CHAHAL SEMI TRUCK/TRAILER REPAIR FACILITY

6100 SCHOONER DRIVE
VAN BUREN TOWNSHIP, WAYNE COUNTY, MICHIGAN

To: OHM
County review R22-0560

OHM review #2 response letter:

STORM SEWER PROFILES

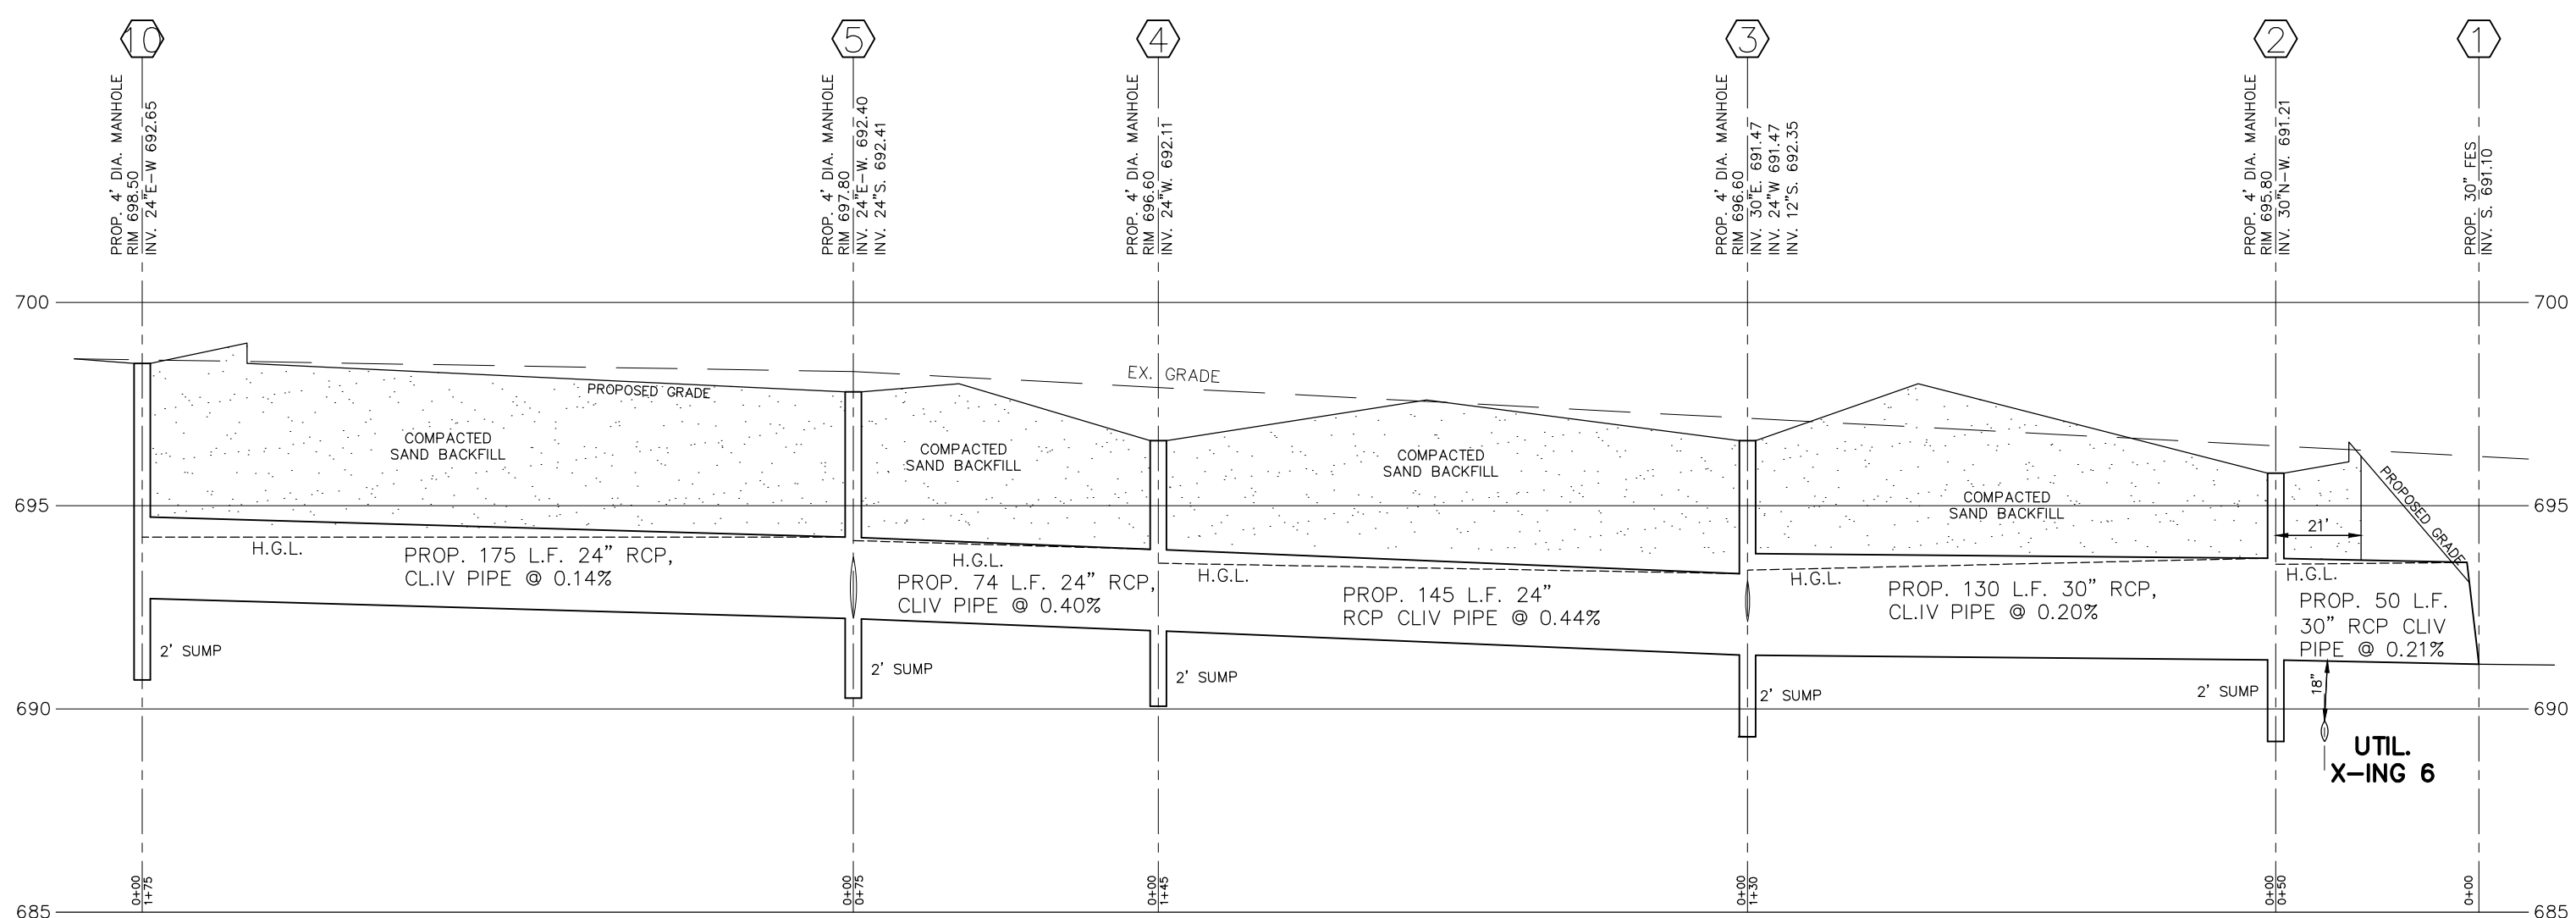
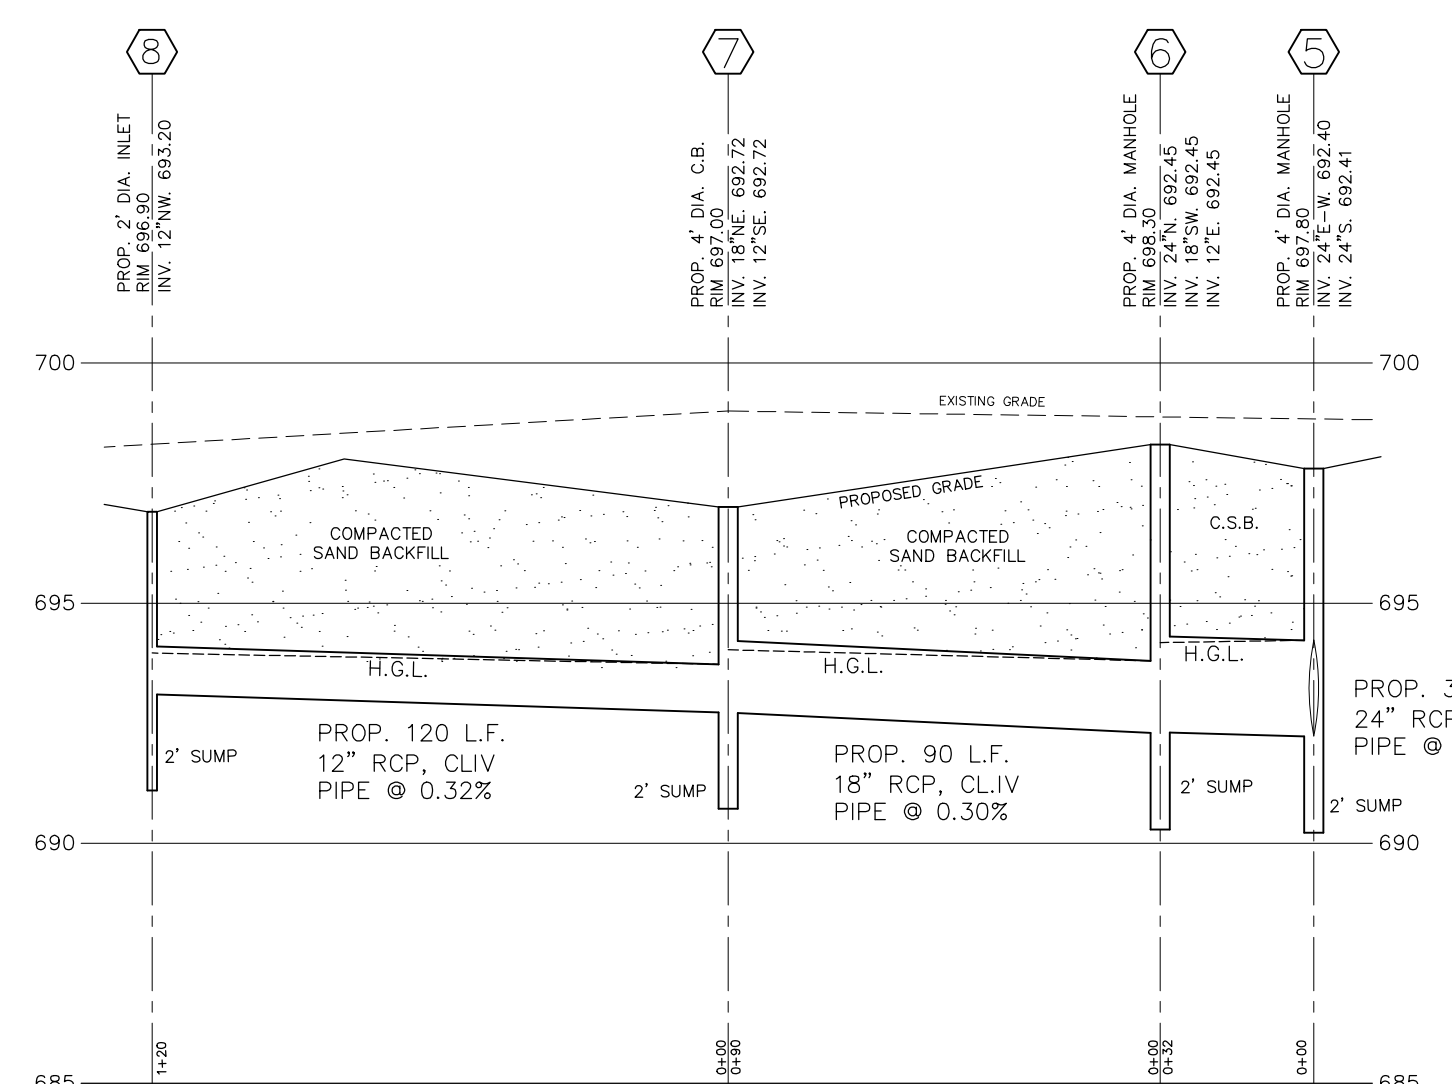
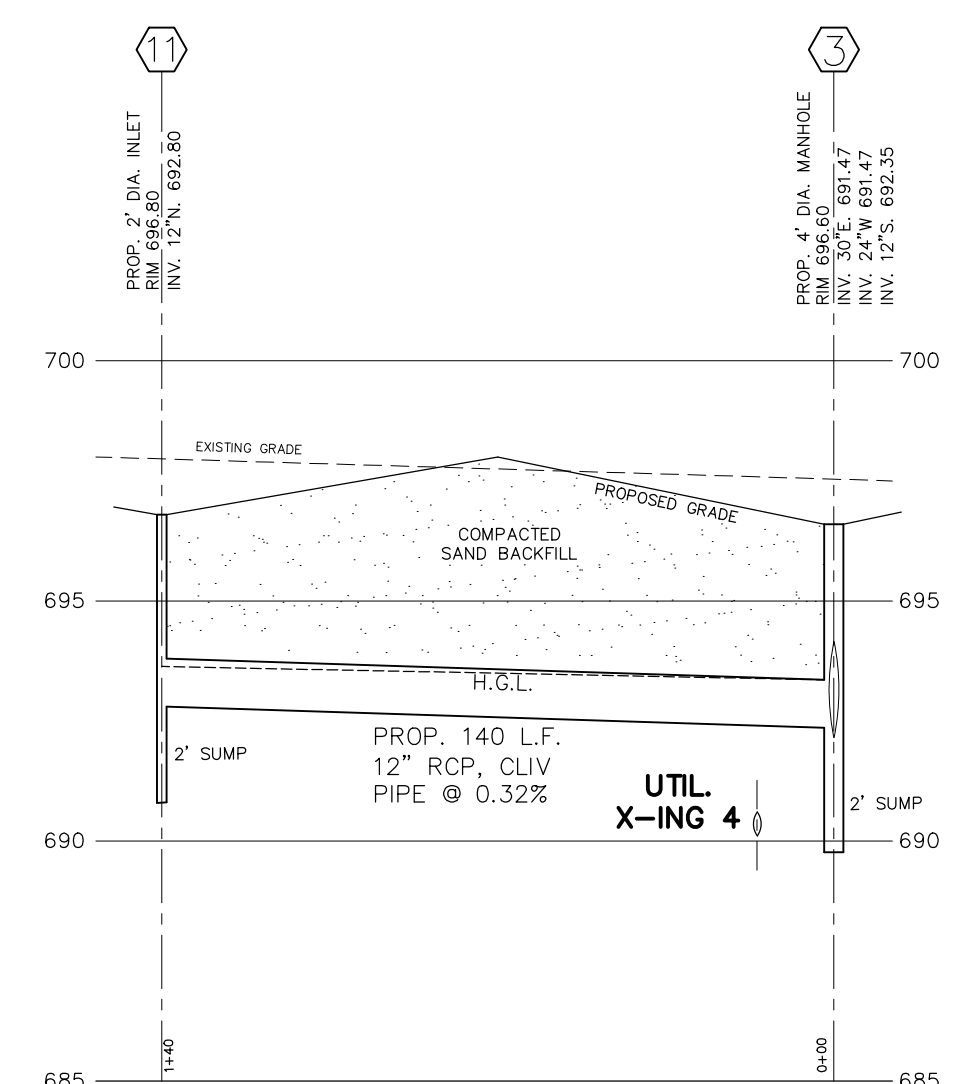
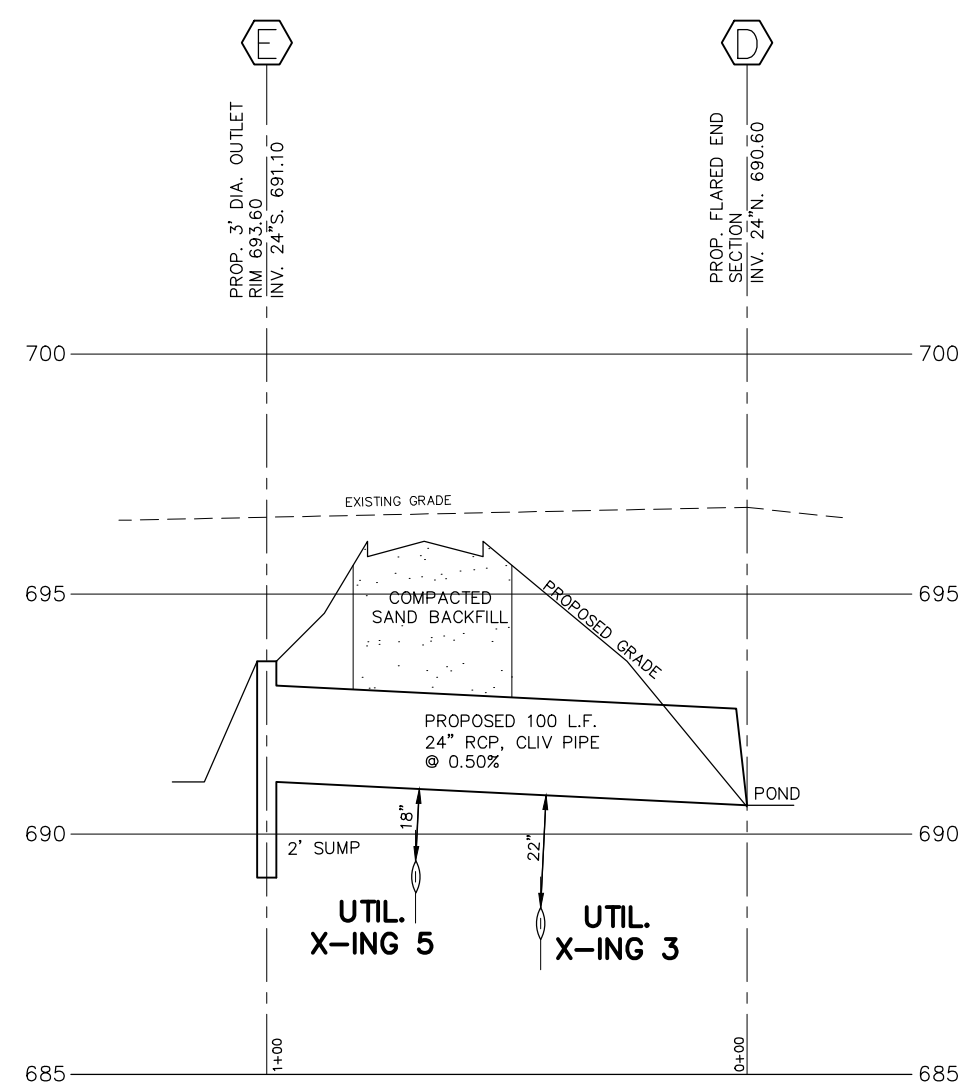
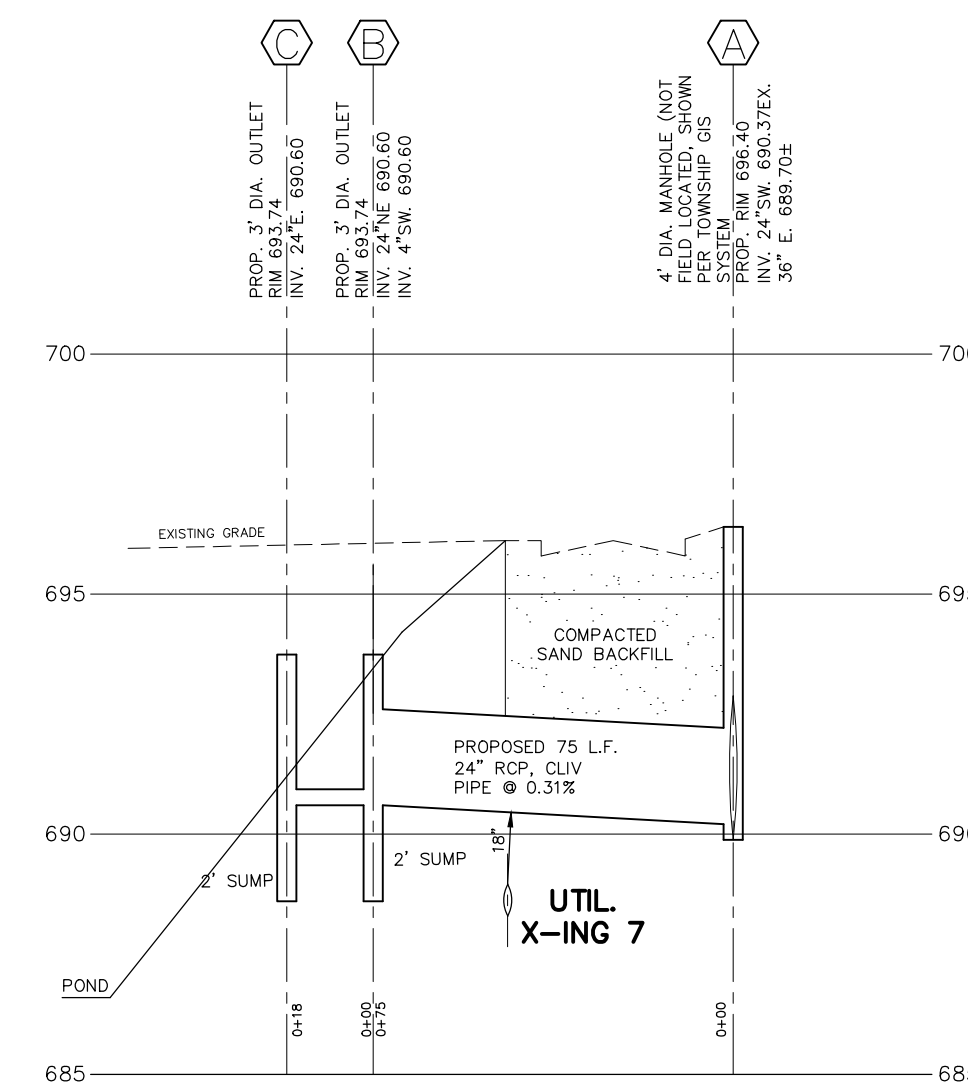
3. Soils information shown on sheet #7 along with a statement of our findings.
4. "D" is not a manhole; it is a flared end section as revised on profiles. Invert elevations have been added to catch basins along the southerly property line. All obtainable existing storm sewer information is shown on the plans.

9. Storm sewer management calculations have been revised.
10. HGL calculations have been added to storm design table.
11. Storm sewer run D-E has been revised. Storm sewer run B-A has also been revised.
